3rd & Cherry

DESIGN REVIEW BOARD RECOMMENDATION MEETING

April 2, 2019

Project Address: **601 4th Avenue**
SDCI Project #: **3028747**

Level 1 Plan Arrival Plaza

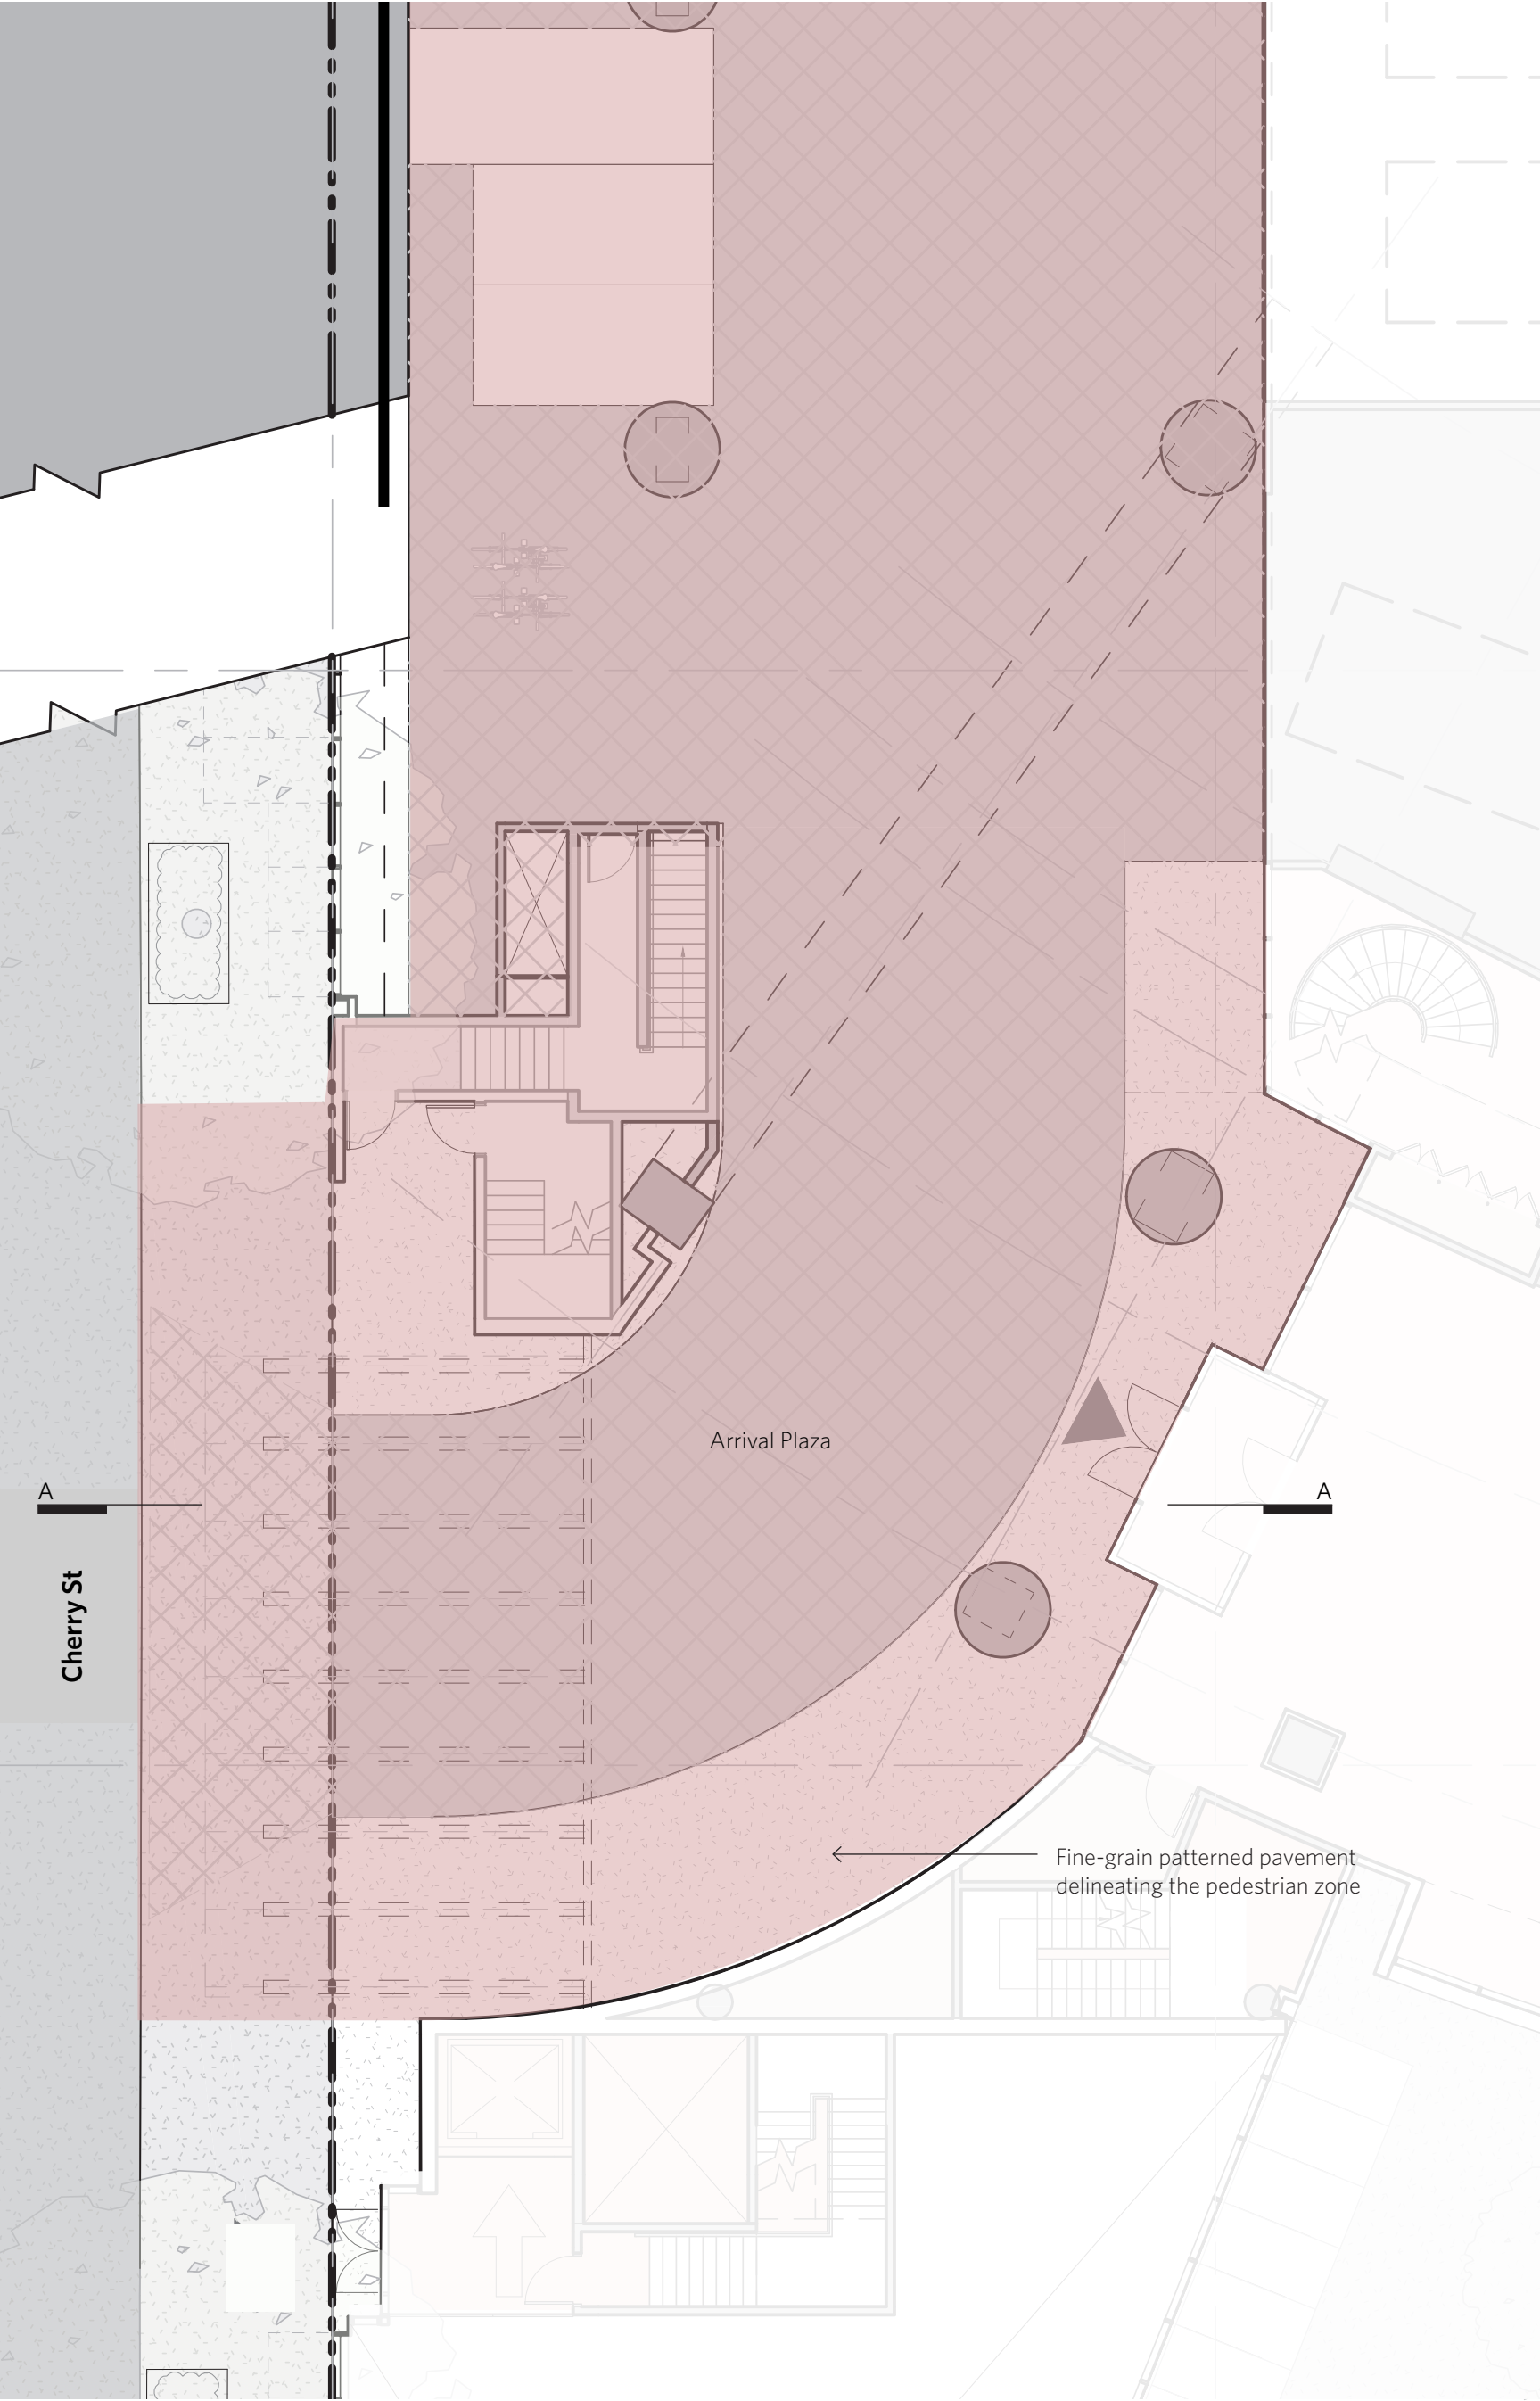
The Board strongly supported the consolidated design for vehicular and loading access, in particular the integrated loading design which conceals loading functions when not in use. The Board agreed the solution minimizes the impact on the pedestrian realm.

The Board noted that the success of the recessed vehicular access relies on the design development and recommended carefully studying the proportion of the overhang, relationship to adjacent retail, narrowing the width of the vehicular zone and fine grained pavement pattern to delineate the pedestrian zone. For the next meeting, the Board requested enlarged sections and a study model of the area. (B3, E1, E2, D6)

The consolidated design for vehicular and loading access was maintained and will be concealed when not in use.

The configuration of the vehicular entrance off Cherry Street has been revised to accommodate an internal arrival plaza with the following components:

The width of this entrance has been reduced as per the boards recommendation which increases retail frontage along Cherry Street and improves the pedestrian experience.

The massing and overhang has also evolved. It is further expressed by a large canopy that overhangs the sidewalk for weather protection, while framing the entrance and announcing the residential lobby.

ADA accessibility to the entrance has also been resolved with gradual grading, as the scheme's entrance was previously quite steep.

Level 1 Floor Plan

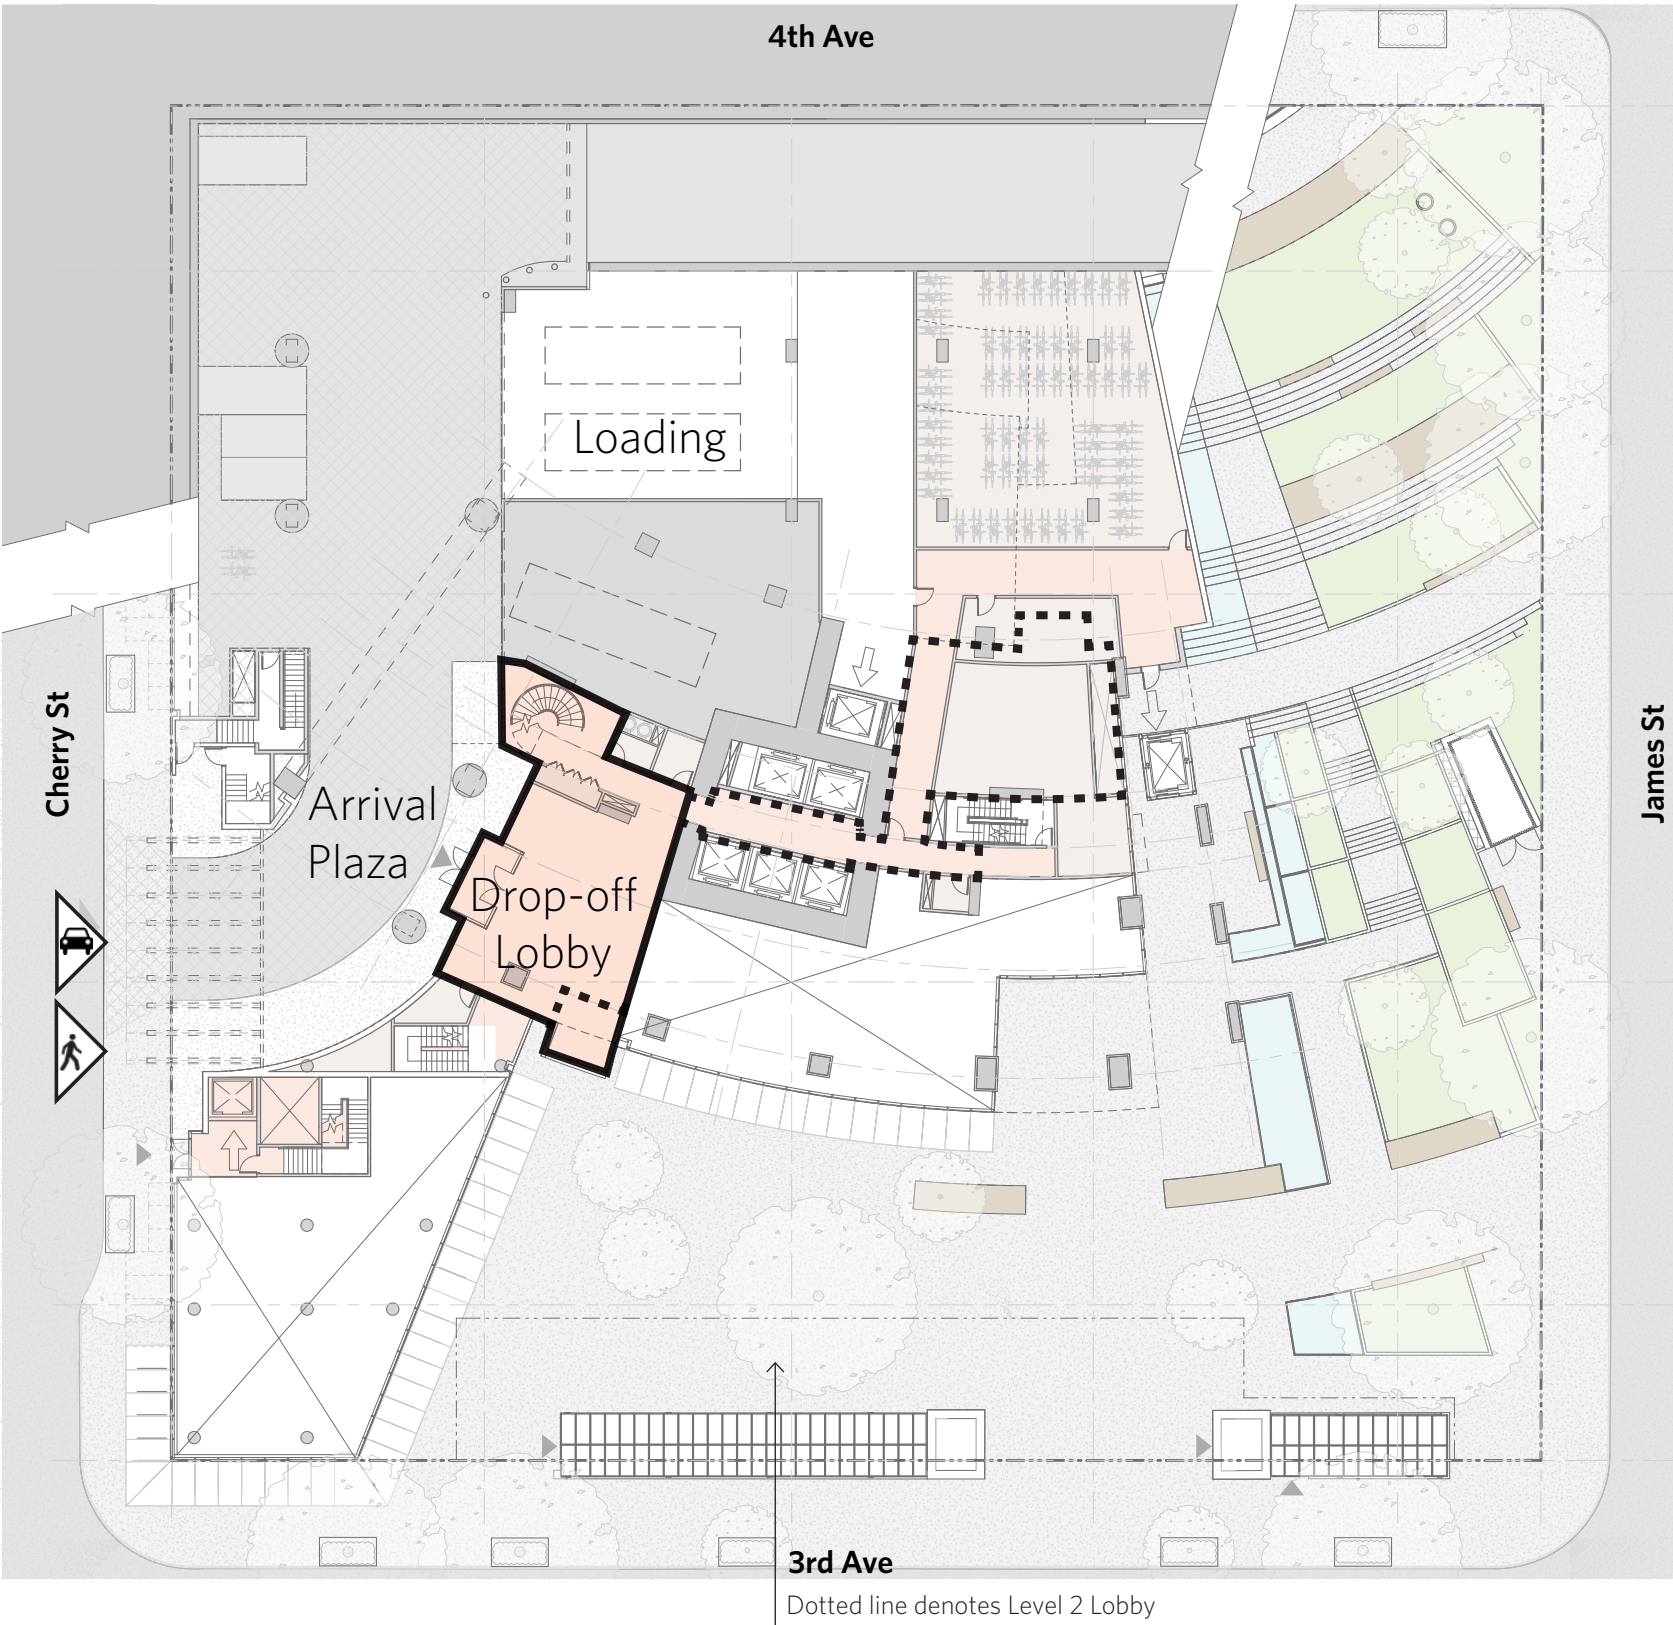
To reinforce the visibility of the residential tower main entry, the Board recommended relocating the entry to along the street frontage or at the corner. (C4)

The project now features two residential entrances:

- Vehicular Entrance off Cherry Street
- Pedestrian Entrance off Fourth Avenue

The new addition of the residential lobby off of Fourth Avenue provides a scenic residential entrance adjacent to the terraced gardens and water features. The residential entrance off Cherry Street, however, provides a grand internal arrival plaza, easily accessible by vehicle and pedestrians alike. It is announced by a large canopy, stone walls and signage.

Both entrance lobbies are connected by a grand feature staircase.

EDG 2 Retail Overlook

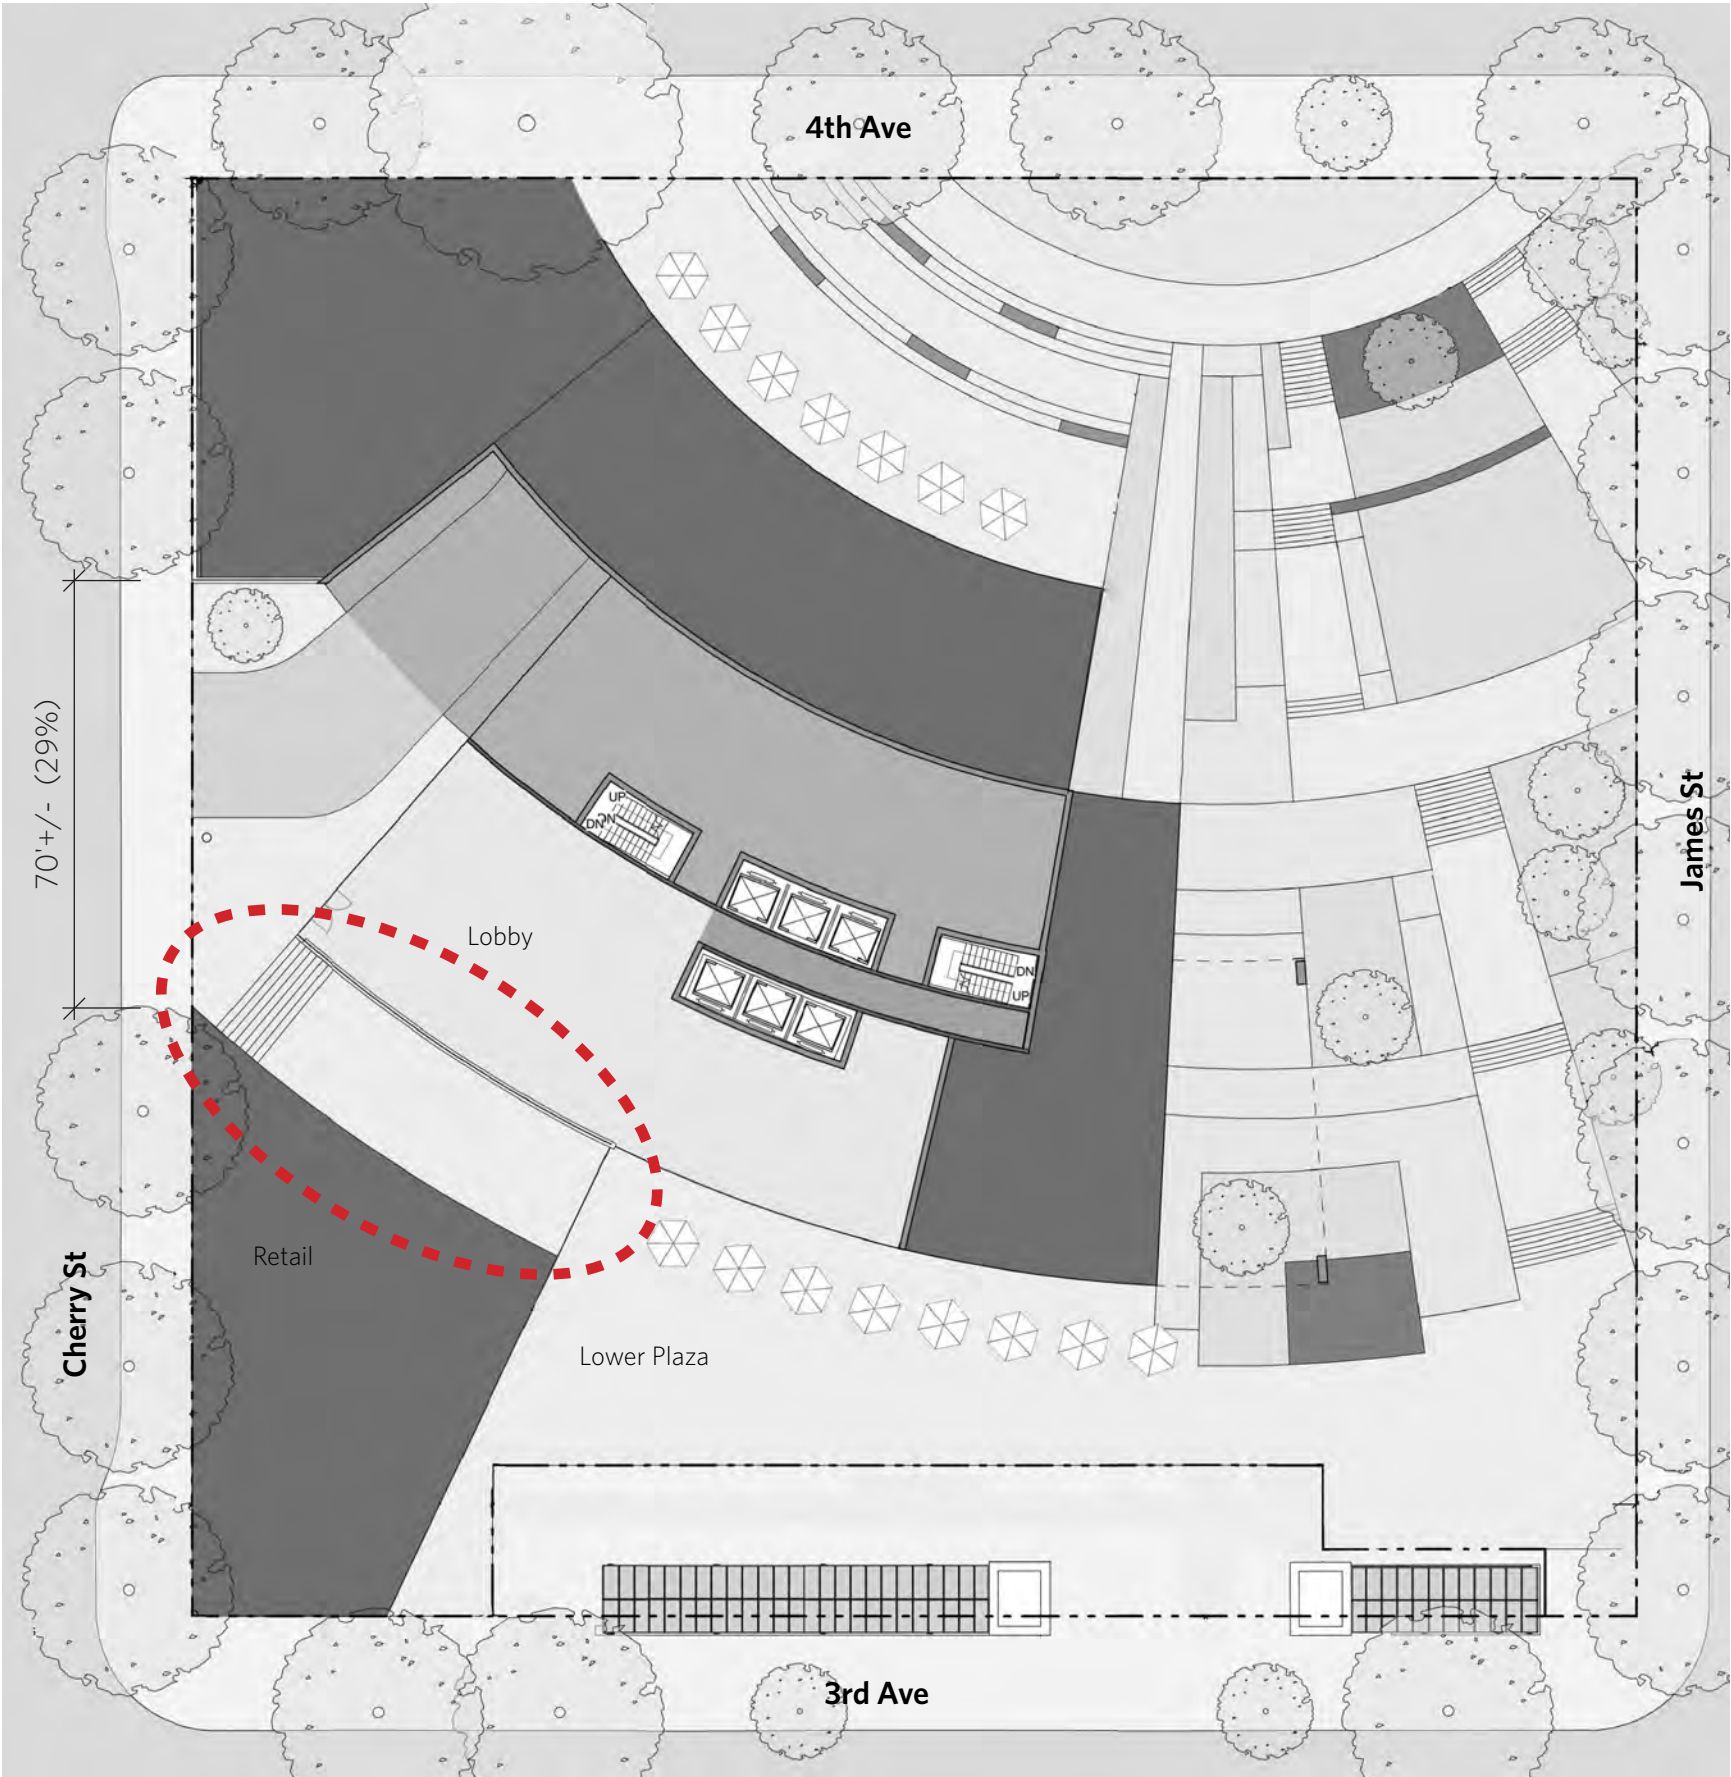
The Board unanimously agreed that the retail overlook should be avoided as it creates a dead end condition with safety challenges. For this area, the Board recommended studying a pass through space with a wider opening which could act as a secondary route through to the open space and transit stations. Several members of the Board also indicated additional retail could also be a potential solution as it would reinforce the street wall. (B1, B3, C1, C3, D1, D6)

A pass through route was studied following EDG 2. The following page contains this earlier scheme. A few challenges were posed with this option:

- 16'-0" grade difference
- Not ADA compliant
- Breaks up Cherry Street

Due to these challenges, as well as the Board's recommendation to create a stronger street wall along Cherry Street, the pass-through was replaced by a stronger Street Wall, as shown in the remainder of this packet.
